## ASSESSMENT REPORT

47-50 The Esplanade, Ettalong Beach  
MP 09\_0121 MOD 4

Figure 2: Approved and proposed Level 6 and rooftop floor.

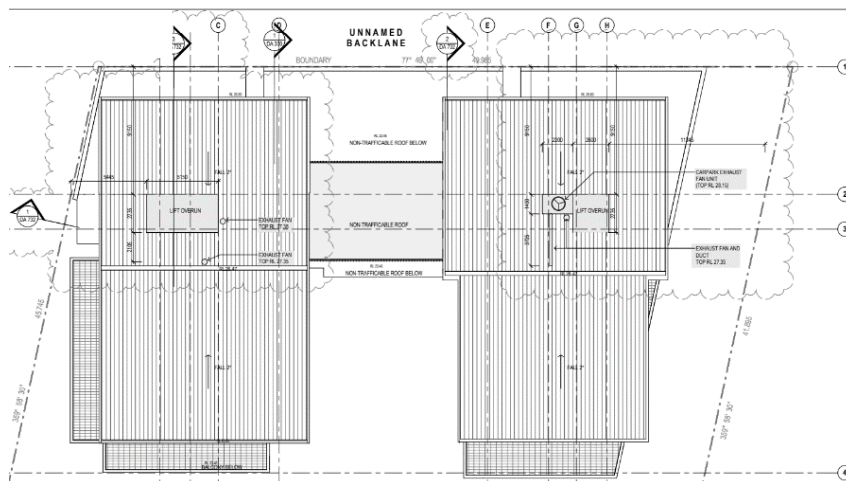
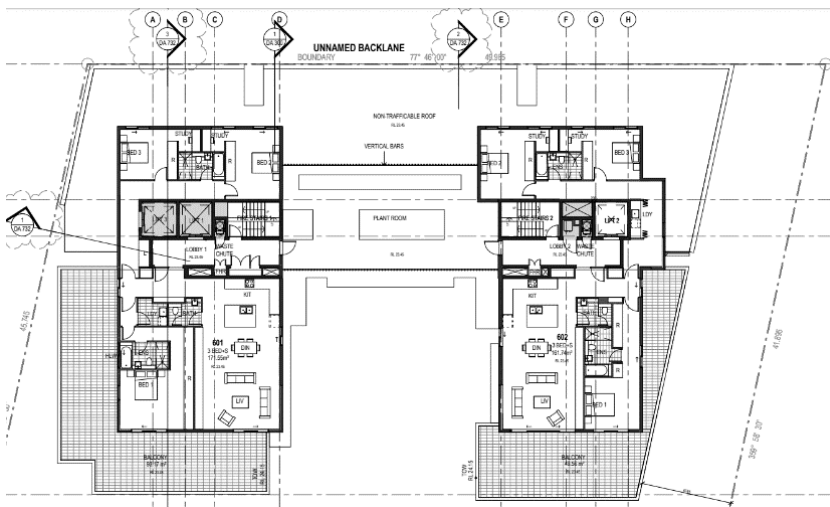
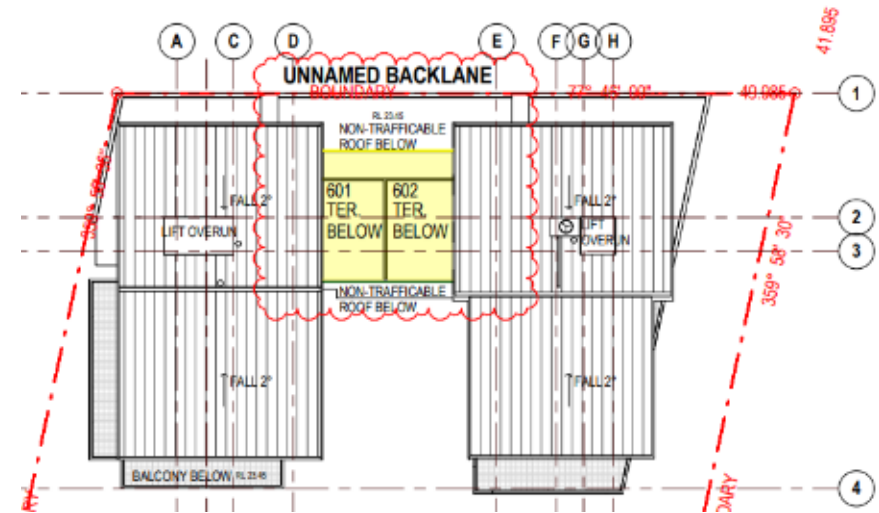
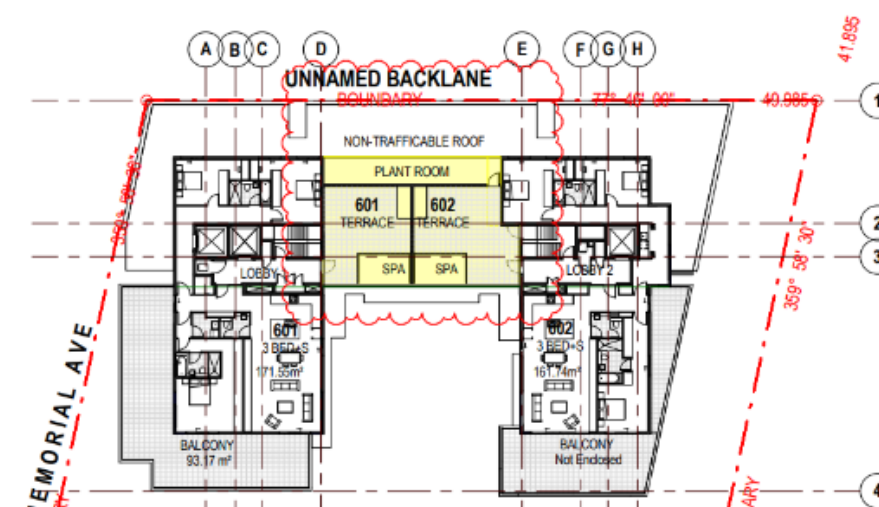
- extending the northern edge of the non-trafficable roof area, relocating the plant room within this space and providing plant room access from apartment 602;
- creating private terraces for apartments 601 and 602 from space used from the previously approved plant area;
- constructing a masonry wall dividing the two terraces; and
- installing a free-standing spa and free-standing barbecue on each private terrace.

**Figure 3:** Approved Southern elevation.

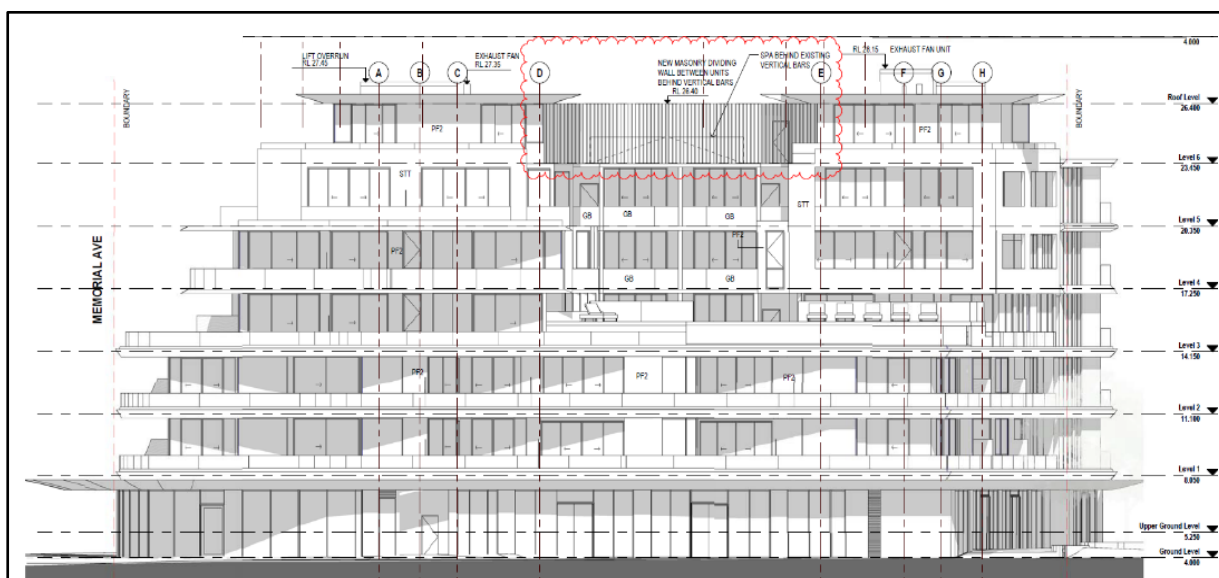
- impacts on surrounding properties;
- the potential visual impacts associated with the proposal would be mitigated by maintaining the previously approved vertical bars screening the proposed terraces and plant room. As shown in **Figure 3 and 4** the relocation of the plant room will not substantially alter the buildings appearance;

- potential overlooking from the proposed terraces towards other surrounding units would be appropriately mitigated by the retention of the previously approved screening (**Figure 4**) along the full frontage of the terraces;
